CPED STAFF REPORT

Prepared for the Heritage Preservation Commission
HPC Agenda Item #3
February 16, 2016
BZH-29007

Property Location: 2901 Hennepin Avenue
Project Name: Old Walker Library Deck Addition
Prepared By: Lisa Steiner, Senior City Planner, (612) 673-3950
Applicant: MacDonald & Mack Architects
Project Contact: Amy Meller
Ward: 10; adjacent to 7
Neighborhood: Lowry Hill East; adjacent to East Isles
Request: To allow the construction of a new deck and other exterior modifications.
Required Applications:

1 | South Elevation: New Door Detail
 A500 | 1/4" = 1'-0"

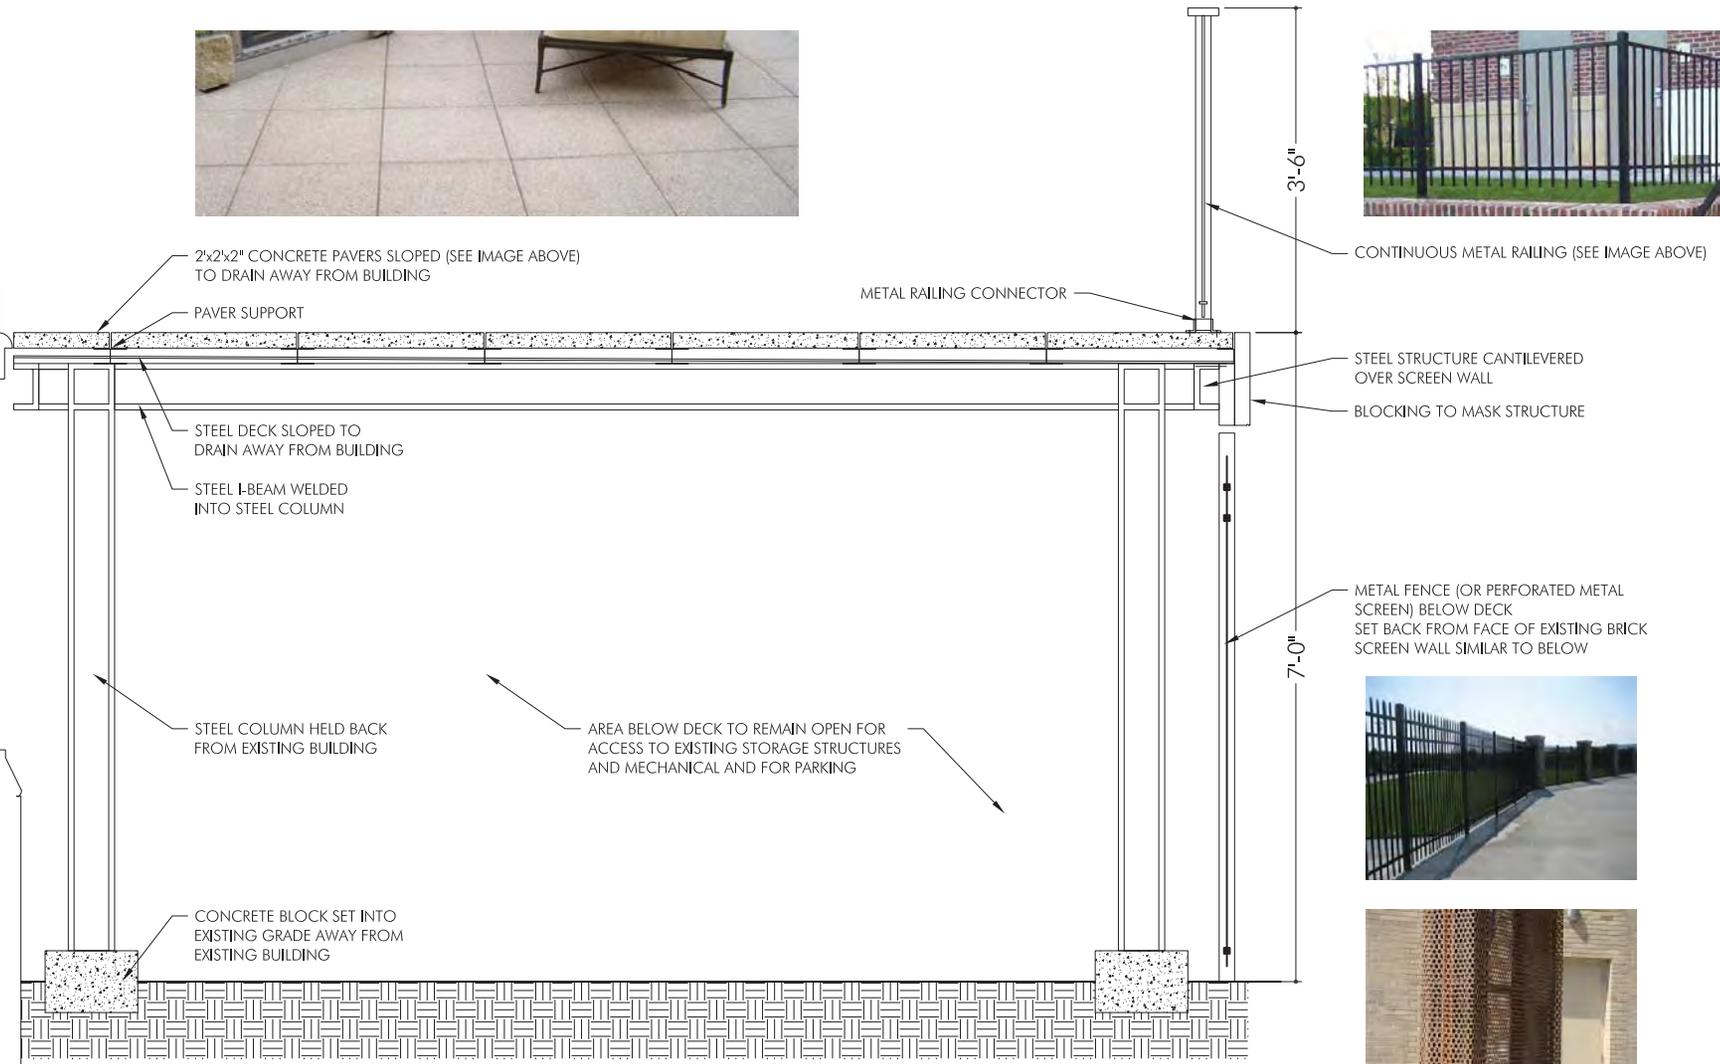
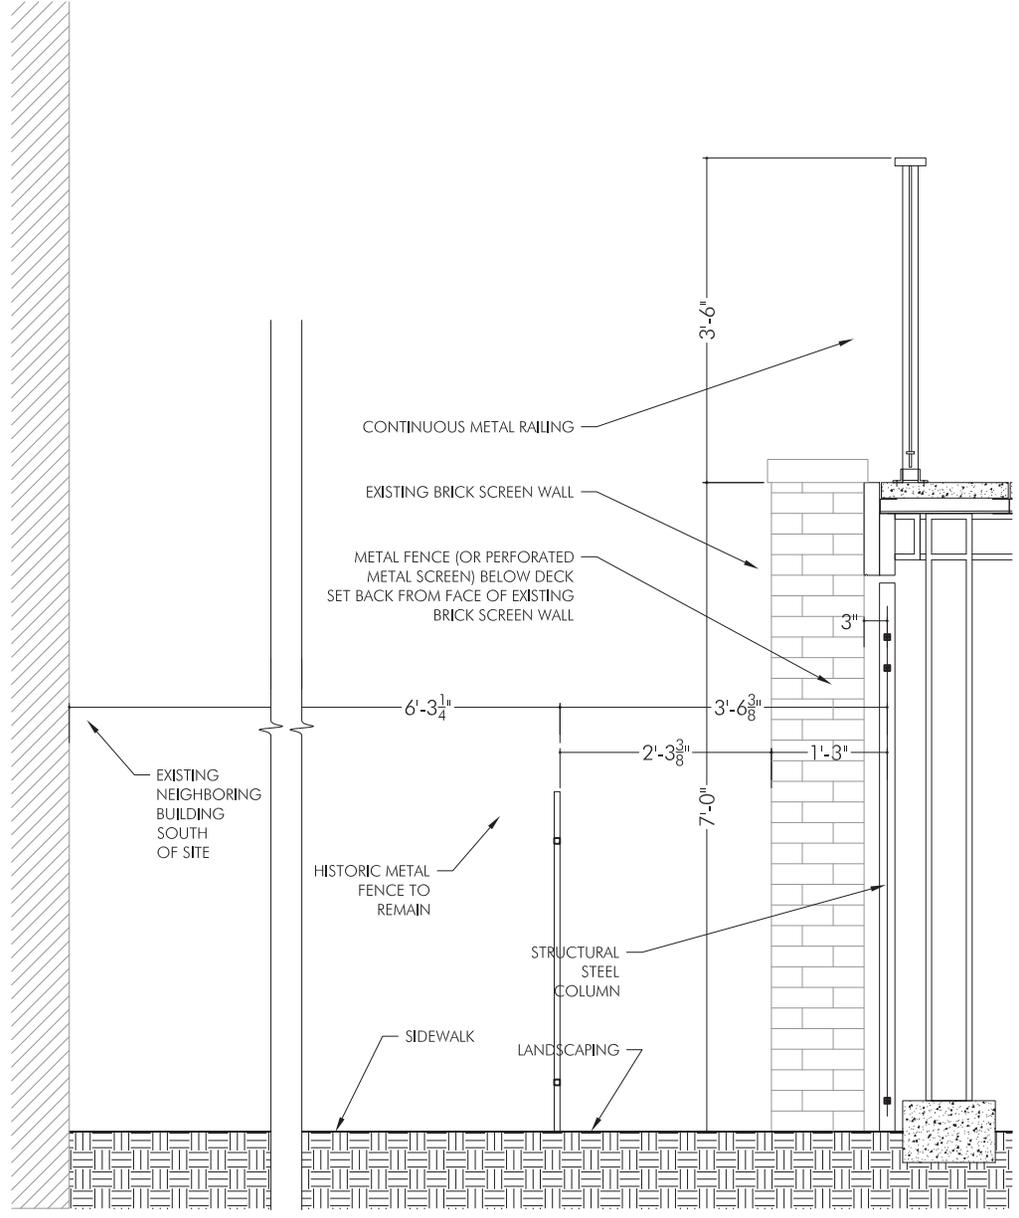
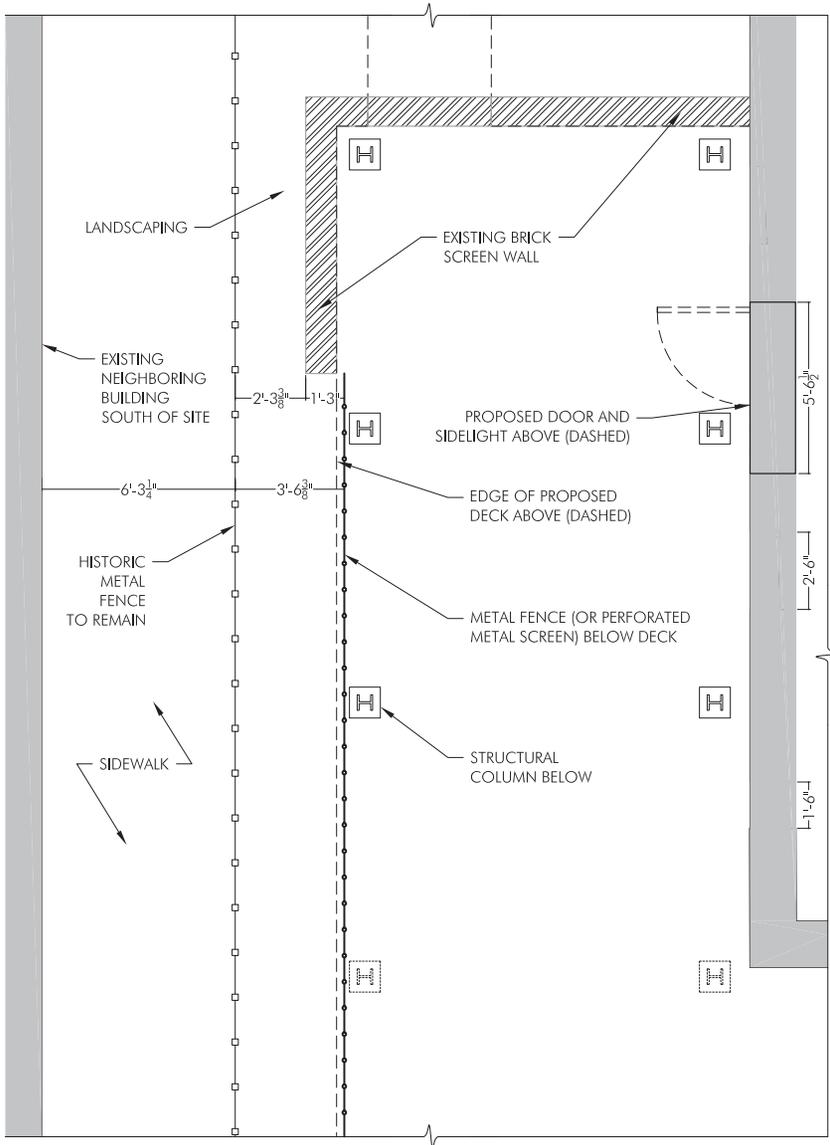
The proposal to cut a new door to access the deck from the first floor of the building would require the removal of a portion of a limestone windowsill and approximately 38 square feet of the brick wall. Considering that this is a secondary elevation of the building, staff finds it reasonable to propose a new entrance on this façade. However, this proposal would impact the distinctive tripartite window design that is present on both the north and south facades of the building in what was formerly the main library area of the building. It would also be somewhat visible from Hennepin Avenue.

Staff recommends that the south-facing window 20 feet to the east of the proposed opening (“Office 1” on the submitted plans) be adapted for the doorway rather than cutting in an entirely new opening as proposed. This option will minimize the amount of historic material lost. Additionally, because the “Office 1” window is located at a portion of the building that steps back about 10 feet, the opening would not be visible from Hennepin Avenue. Staff also recommends a condition of approval that the brick and limestone material removed be reused as feasible. Any additional brick or limestone removed in good condition shall be saved and stored on site for use if necessary for future rehabilitation. The window that would be removed is likely a replacement from the 1980s renovation of the building. Because the “Office 1” option minimizes the amount of material lost, it would be more easily reversible than cutting in the new opening at the proposed location.

3. The proposed new doorway opening on the south elevation below the tripartite windows is not approved. The single window opening location identified as "Office 1" on submitted plans may be modified as shown to provide a doorway to the proposed deck.

5 Office 1: Construction Elevation

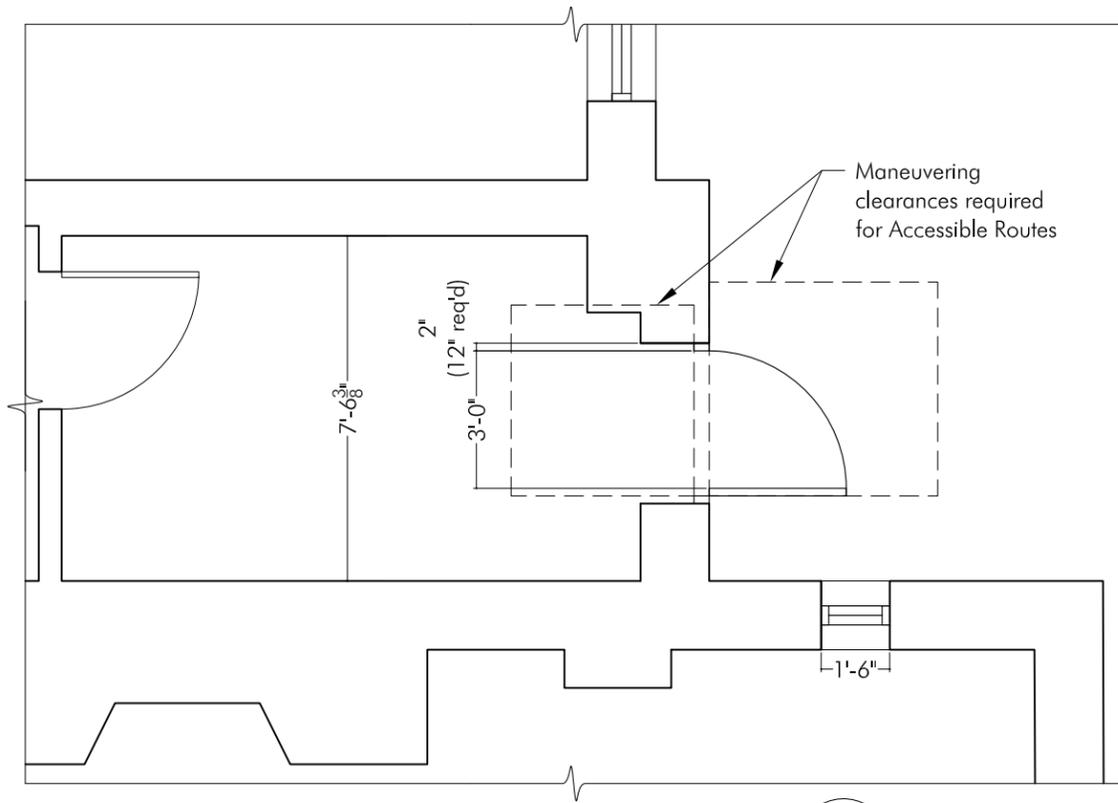
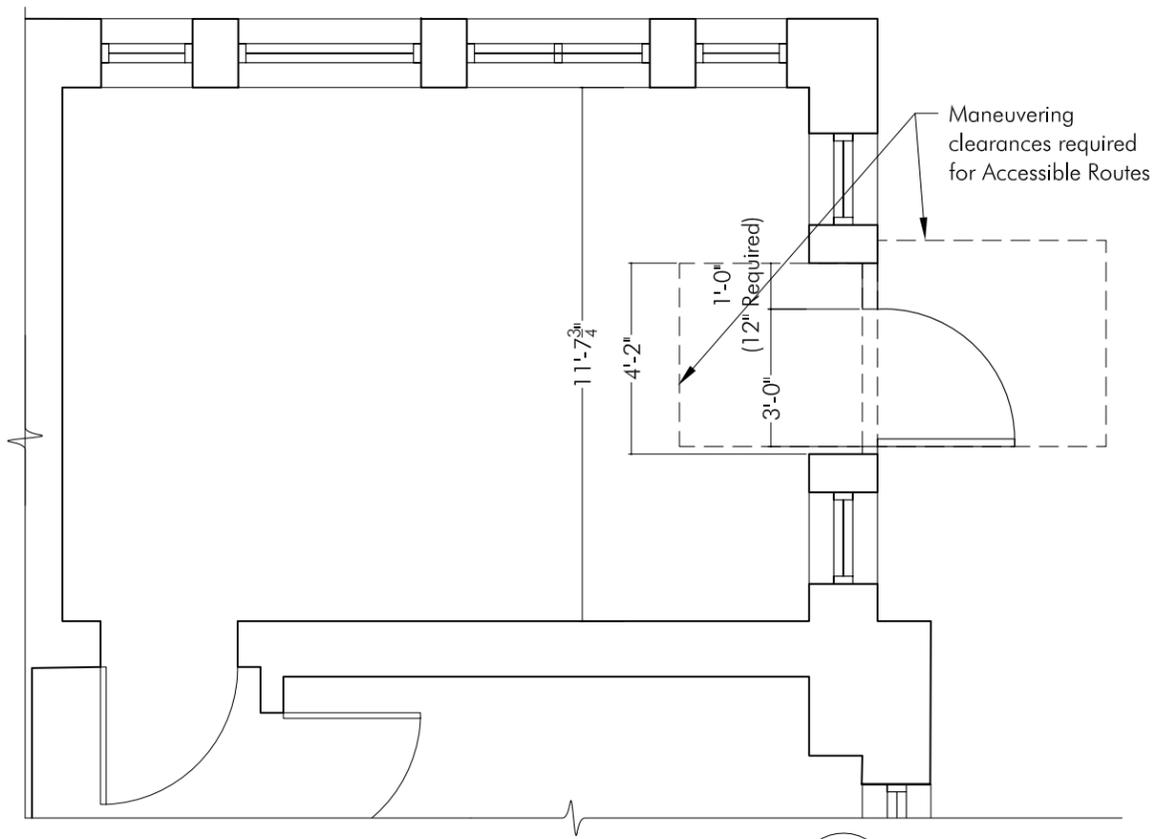
The other potential opening on the south elevation, titled “Office 1” on the submitted plans, would be located approximately 20 feet to the east of the proposed opening in a portion of the building that is stepped back nearly ten feet. This option would require the removal of one existing window, a limestone header and windowsill, and an approximately 5 square foot area of the brick wall.

In comparing the three opportunities, staff finds that the “Office 1” would have the least impact on building material as it would involve the modification of one window opening into a doorway opening, rather than introducing an entirely new opening as proposed or altering two window openings in an existing four-window pattern. Staff recommends a condition of approval that the “Office 1” location be modified instead to provide access to the deck. Staff also recommends that the limestone and brick that is removed shall be reused if possible and that any other limestone or brick materials removed and in good condition shall be stored on site for future rehabilitation efforts.
